# ADA Curb Ramp New Construction Inspection Form (Parallel)

Nw 314th ave.

24952.54

Nw. Cottage st

PARALLEL RAMP (PL)

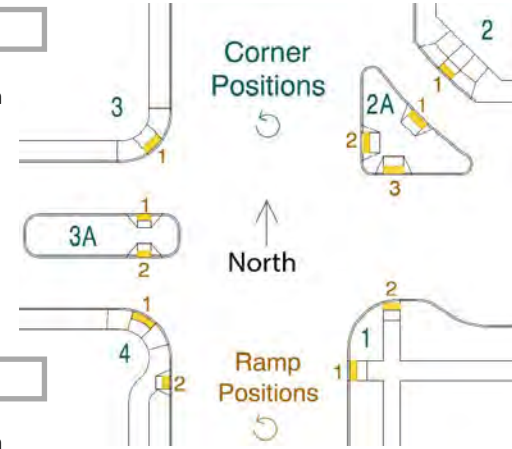
9.4  $\leq 2.0\%$  ☐  $> 2.0\%$  ☒

0.5  $\leq 1/4"$  ☐  $> 1/4"$  ☒

12.6  $\leq 8.3\%$  ☐  $> 8.3\%$  ☒

13.4  $\leq 8.3\%$  ☐  $> 8.3\%$  ☒

No dome, no RR2, no RR3
